DEVELOPMENT REVIEW BOARD REPORT

89-DR-1998#2
Barton House Phase 2

Request site plan and elevation approval for Phase II of the Barton House an assisted living facility.

PROPOSED SITE PLAN

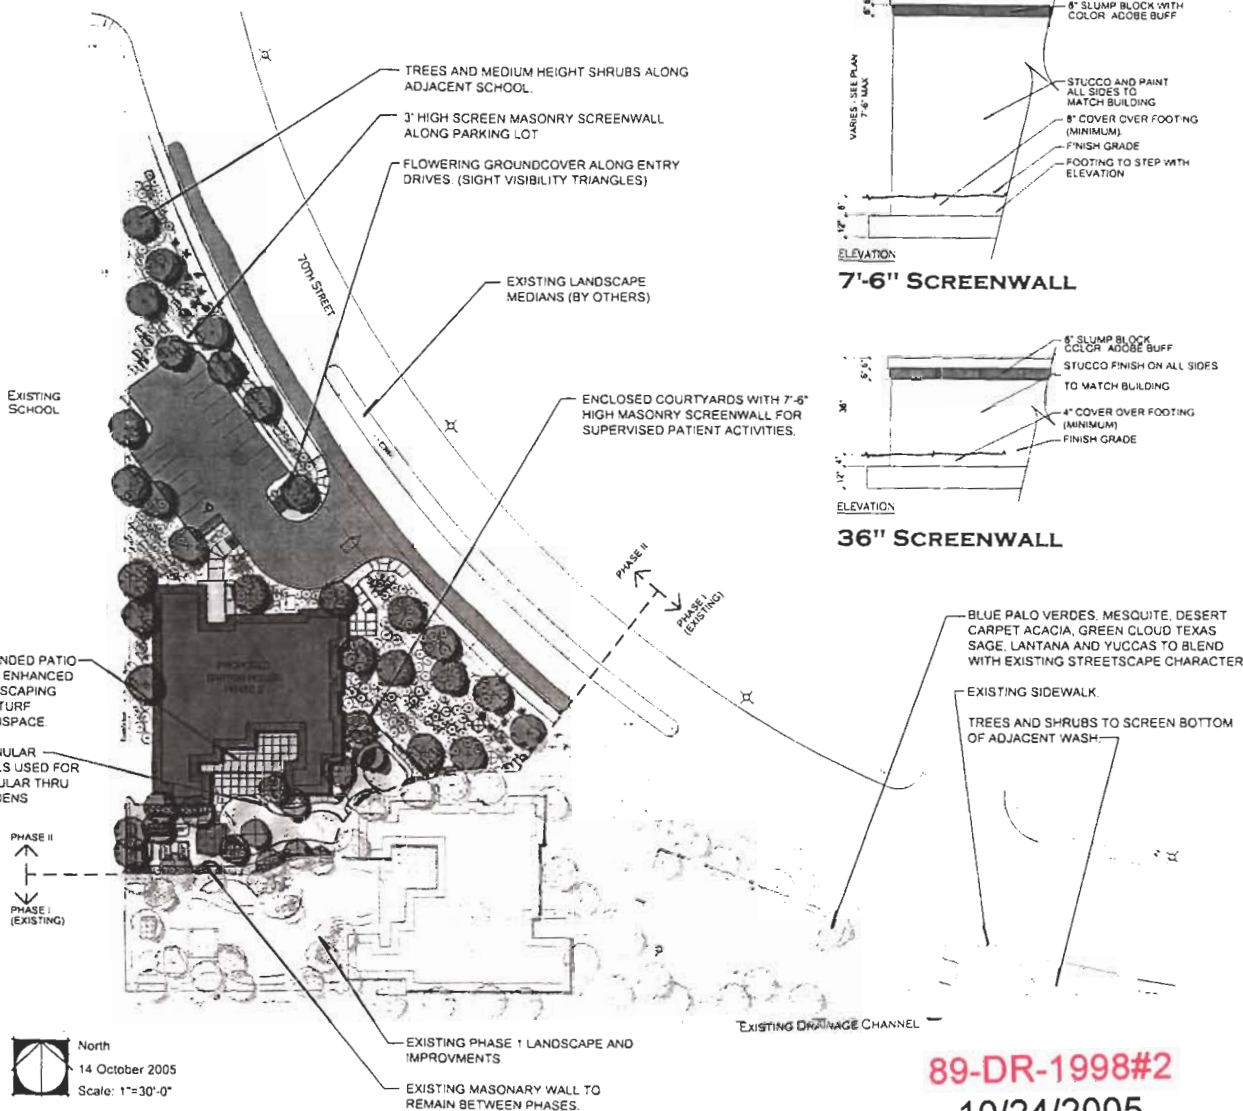
1. PROVIDE IDENTIFICATION TO DESIGNATE FROM STREET OR DRIVE - MUST BE ON ALL PLANS (SHEET A-1)
2. FIRE LINES & EMERGENCY ACCESS SHALL BE PROVIDED & MARKED IN COMPLIANCE WITH CITY ORDINANCE & IFC AT THE FOLLOWING LOCATIONS: 1) PHASE 1 2) PHASE 2 3) PHASE 3 4) PARKING LOT (SHEET A-1)

4. BURST PLANS AND SPEC'S FOR SUPERVISED AUTOMATIC EXTINGUISHING SYSTEM FOR ALL COOKING APPLIANCES, HOOD FRESH AIR EXHAUST FAN (SHEET F-2)
5. PROVIDE KNICK BOX ACCESS (SHEET A-1)

6. BURST PLANS FOR AN OCCUPANT LIGHTING SYSTEM PER APPROVED REVISED CODES (SHEET E-1/2) USE OF MAG LOCKS ON ENTRY DOORS REQUIRES COMPLETE SMOKE DETECTION INSTALLATION THROUGHOUT THE FACILITY.

7. BACKFLOW PREVENTION WILL BE REQUIRED ON CLASS 1 & 2 FIRE SPRINKLER SYSTEMS PER APPROVED REVISED CODES (SHEET F-1)
8. PROVIDE ALL WEATHER ACCESS ROAD PAV. TO ALL BUILDINGS - HYDRANTS FROM PUBLIC WAY DURING CONSTRUCTION.

9. MASTER OF SCHEDULED FIRE HYDRANTS ON DEVELOPER'S SHALL HAVE THE REQUIRED HYDRANTS INSTALLED & COMPLETION PRIOR TO THE FOOTING INSPECTION. DEVELOPER TO PROVIDE MAINTENANCE OF FIRE DEPT. RESPONSIBILITY ON COPY OF CURRENT CITY APPROVED CIVIL WATER PLANS. FIRE SPRINKLER CONTRACTOR FOR LOCATING NEW AND/OR EXISTING HYDRANT WATER MAIN SUPPLY DATA SPACED MAX. 10' ON 10' AT 800 PSI (CIVIL SHEET P-1)

10. PORTABLE FIRE EXTINGUISHERS SHALL BE INSTALLED (SHEET A-1)
11. EXIT & EMERGENCY LIGHTING SHALL COMPLY WITH THE CITY ORDINANCE & IFC (SHEET E-1)
12. SUBMIT HAZARD SHEETS & AGGREGATE QUANTITY DATA ON ALL HAZARDOUS MATERIALS INCLUDING FLAMMABLE, PESTICIDES, HERBICIDES, CORROSIVES, OXIDIZERS, ETC. NFPA 704 RISK RATING & STORAGE SEPARATION, A COMPLETED APPLICATION FOR HAZARDOUS MATERIALS PERMIT SHALL BE PROVIDED WITH BUILDING PLANS. SHEETS WILL BE PROVIDED BY OWNER.

13. FDC BATTERY CONNECTIONS FOR SPRINKLER AND/OR STANCHION WILL BE LOCATED PER ORDINANCE OR AT AN APPROVED LOCATION PER SIZE 2 1/2" X 4" X 1/2" POLYURETHANE CLEAR OF OBSTACLES (SHEET A-1)

14. NFPA COMBUSTIBLE SYSTEM DESIGN CRITERIA, IT HAS 0.000000 WITH QUICK RESPONSE HEADS - ORC OR 1.000000 KITCHEN PROVIDE EXTERIOR 1/2" HOSE VALVES ON EACH BUILDING.
